SUPPLEMENTAL/BID BULLETIN NO. 2

PROJECT : Generator Set for LANDBANK Aurora Boulevard Office Building under Project Identification No. LBP-GIBAC-ITB-GS-20250312-01

DATE : 11 June 2025

One (1) Lot – Supply, Delivery, Installation, Testing and Commissioning of One (1) Unit 320kW/400kVA Standby Generator Set at LANDBANK Aurora Boulevard Office Building, including Dismantling and Hauling-out of Existing Generator Sets to LANDBANK Antipolo Warehouse.

3 GENSET ROOM DETAIL

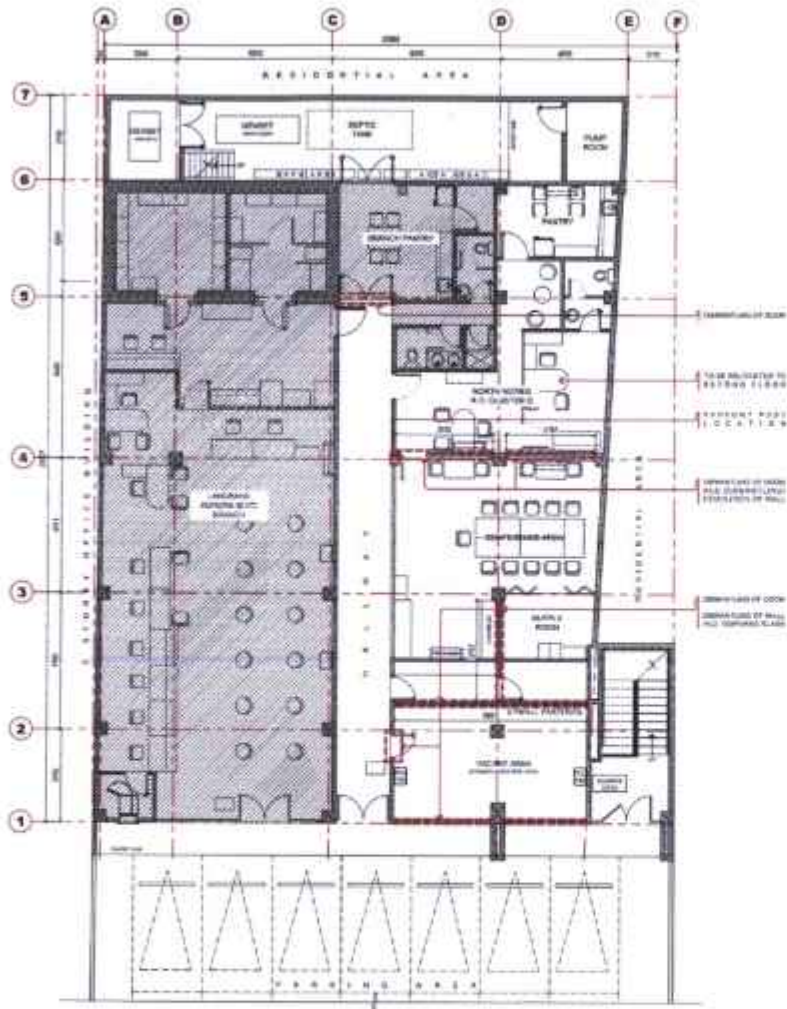
ITEM NO.	PORTION OF BIDDING DOCUMENTS	QUERIES AND/OR SUGGESTIONS	LANDBANK's RESPONSES
1		Provide the detailed plans for construction of the genset house/room and genset foundation (with equipment layout)	Please see attached
2	Terms Of Reference, Electrical Works	Who will supply the 1200A ATS? Please provide details of the ATS (For us to be sure that the 400kva genset will be compatible to the said ATS)	We have parallel project with our engineering department. The installation of ATS was included in their scope (BY OTHERS). Please see attached single line diagram for ATS and CABLE size
3	Terms Of Reference, Installation and restoration work	Please elaborate our scope on the 'Repairs & Restorations' Particulars	Repairs and Restorations will pertain on the civil works, paintings and other damaged/affected on our facility upon delivery and installation of the generator set.
4	Terms Of Reference, Testing and Commissioning	Should we provide dummy loadbanks for the 50%, 75%, 100% (1 hour each) site load testing?	As per TERM OF REFERENCE, on final testing and commissioning at the project site. The load be used will be the load of the building.

ITEM NO.	PORTION OF BIDDING DOCUMENTS	QUERIES AND/OR SUGGESTIONS	LANDBANK's RESPONSES
1		1. Existing Generator set for replacement doesn't have concrete foundation Q. Is their provision of concrete pad for new generator set? If yes, may we request for the design drawings.	Please see attached generator room plan
2		2. For common reference, may we request for the design drawings indicating the following; a. Approved location of generator set and ATS b. Approved conduit or raceway to be used and its route. c. Approved Set, Size and type of wires to be used.	Please see attached single line diagram
